Willamette Mercury TMDL

Model Updates and Response to Questions

Willamette Mercury TMDL Advisory Committee Meeting
March 7, 2019

Food Web Model, Revised Figure 2-1

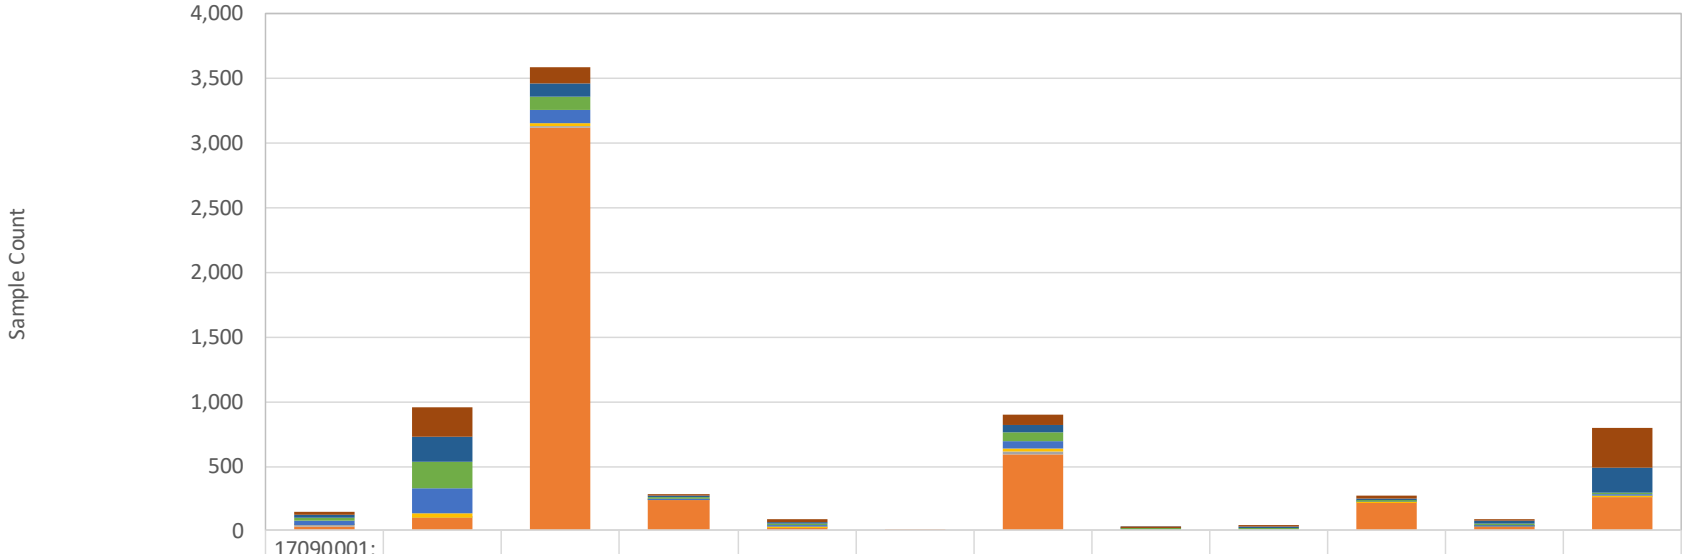
In Figure 2-1 it shows about 10,760 samples have been collected. Yet in Figure 3-5, if you add the n values you get 1,066 samples. That represents 10% of total samples. Why was only 10% of the data included?

Figure 3-5 included only wet-weight fish data from the 8 target species. Figure 2-1 included all fish species as well as some false “non-duplicates” and non-fish (such as clams) that had been coded as fish. “10,760” includes 3,447 dry weight samples, which are not relevant to the FWM. The revised count is now 4,633 wet weight fish samples.

- Post-calibration plot for Northern Pikeminnow

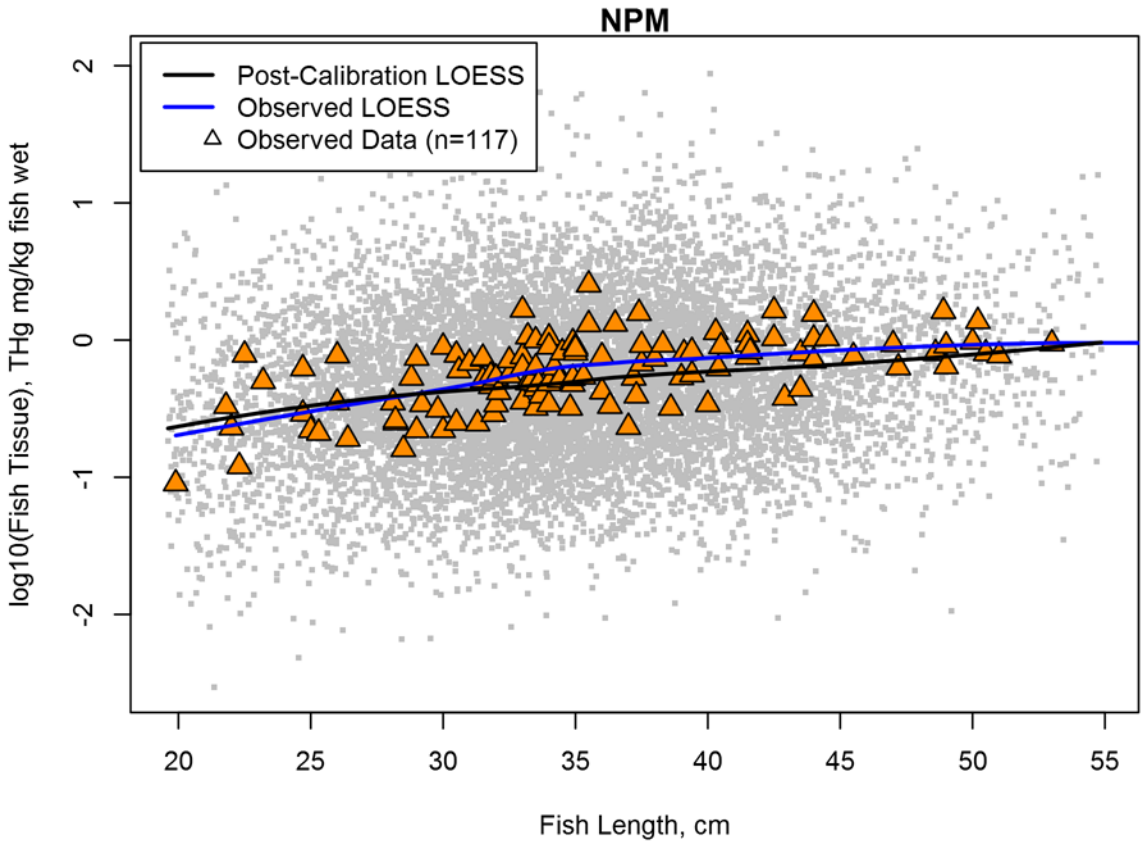
If the northern pikeminnow is the only fish whose Food Web Model parameterization is used in the determination of the target mercury concentration, then why is its calibration in the Food Web Model poor? Why not calibrate to fit the cumulative distribution function for its fish tissue mercury concentration to the available data and allow other fish to have a poor calibration?

We do not characterize the fit for NPM as poor. There are deviations at the tails of the distribution, which may reflect variability and uncertainty in the food web structure, but the fit is matched at the median – which is the basis for BMF calculation. It would not be appropriate to force a better fit for NPM by degrading fit for lower trophic levels, even if feasible, as concentration in NPM depends on bioaccumulation from those lower trophic levels.

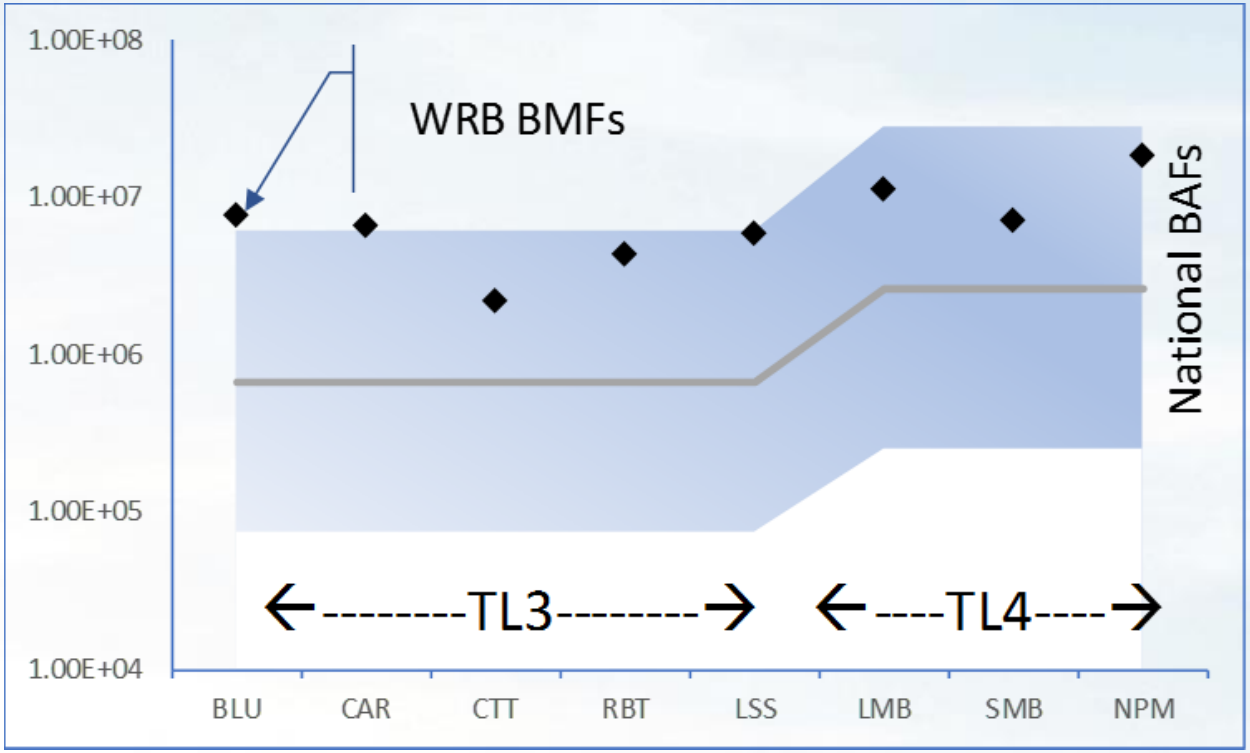
Has the biomagnification factor been compared to available literature?

A section has been added on this topic. The WRB cumulative BMFs are generally near the upper 95%le bound of national BAFs in USEPA (2001)

Mass Balance Model: Atmospheric Deposition

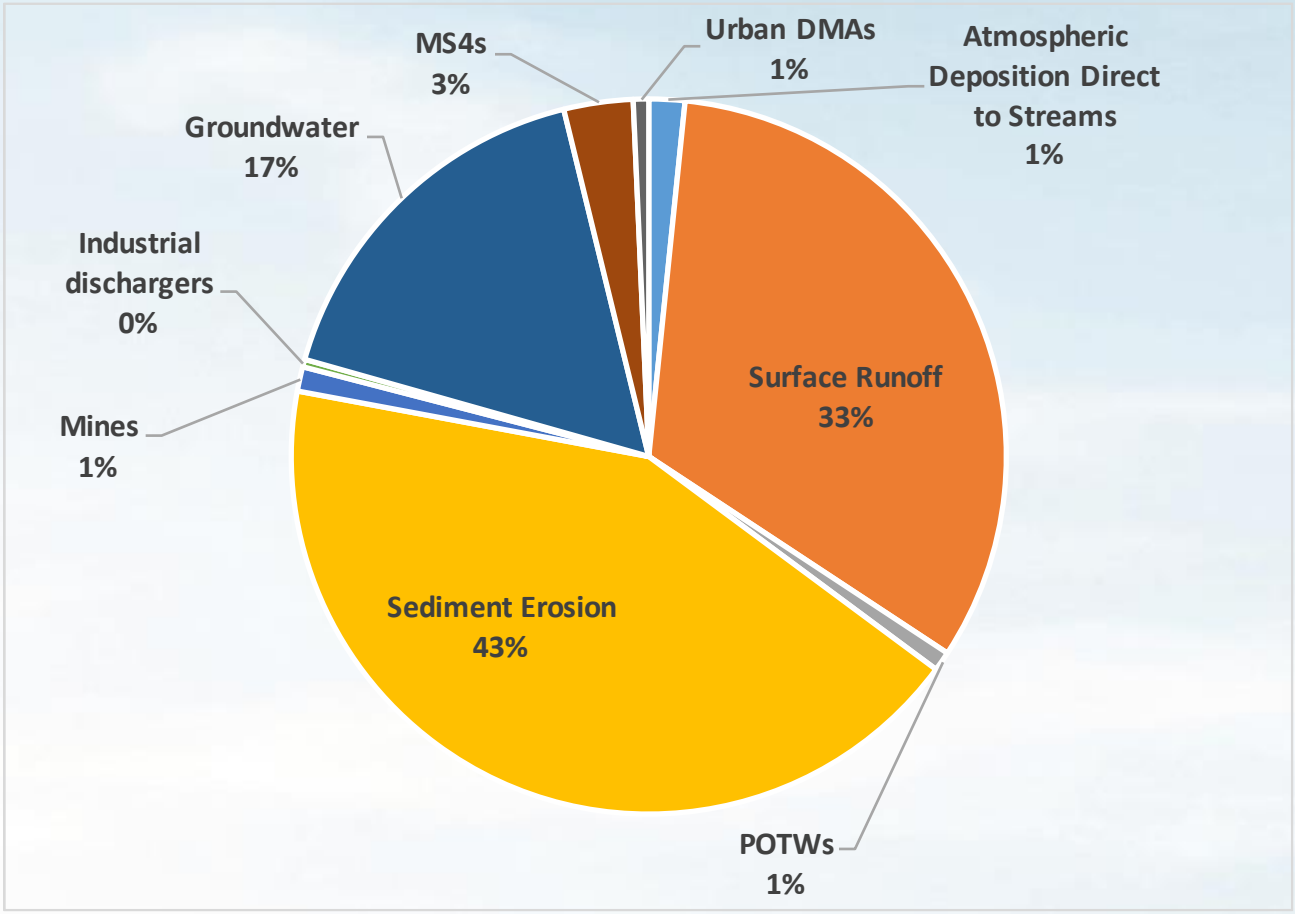
Why does page 9 say the mean annual loading rate at the mouth of the WR is 126.8 kg/yr and on page 63 it says it is 43.1 kg/yr? Then on page 64 it says 44.5 kg/yr compared to the 2006 value of 53.7 kg/yr? Can you provide a table that shows an accounting of all these numbers (wet deposition from different areas plus dry deposition from different areas, etc.) and how they add up?

126.8 kg/yr (p. 9) is the estimate from the 2006 TMDL of total Hg load from all sources. Page 64 referred only to loads attributed to atmospheric deposition, both directly and indirectly. We have modified the terminology to refer to direct atmospheric deposition to water and loads associated with surface runoff and erosion, with extensive source tables.

A majority of the surface runoff and sediment erosion loads are ultimately derived from atmospheric deposition

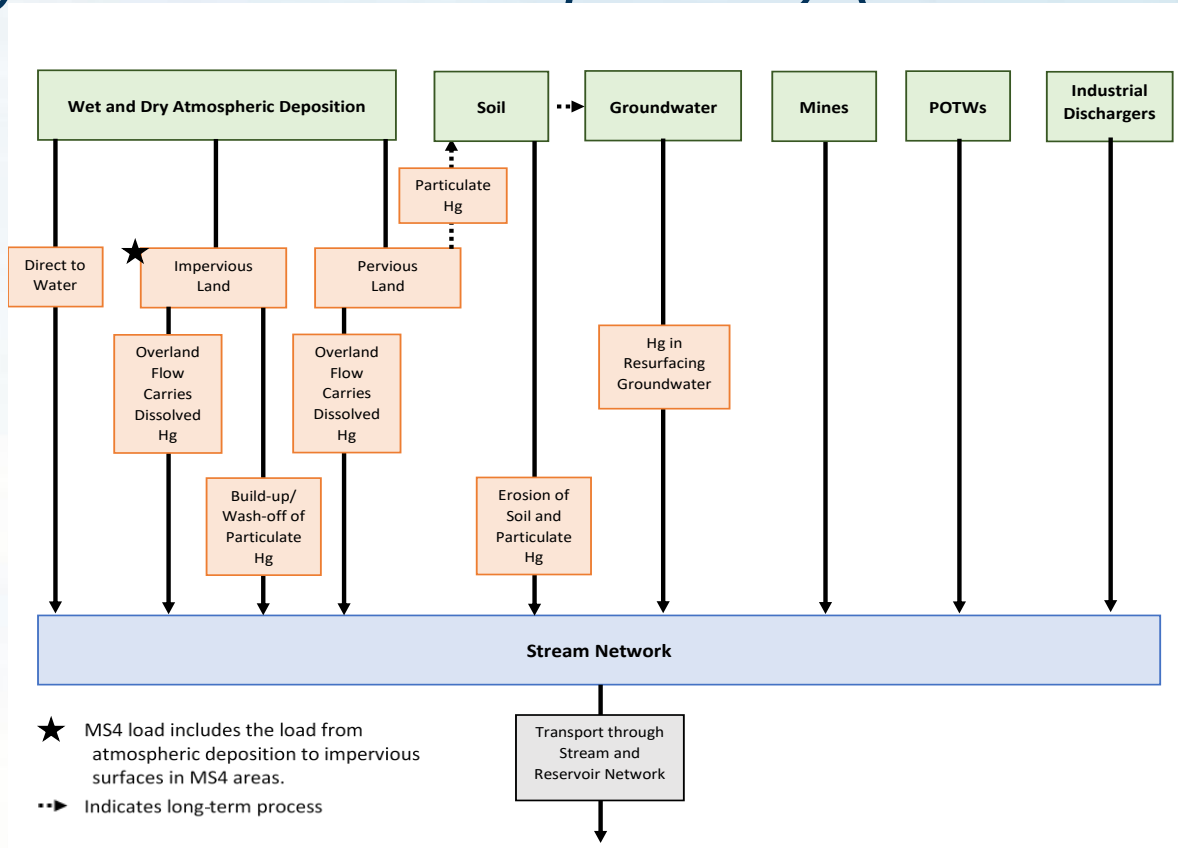
In Figure 5-2, can you explain how the overland flow and build up wash off boxes are different from each other and how they are modeled separately (under impervious area)?
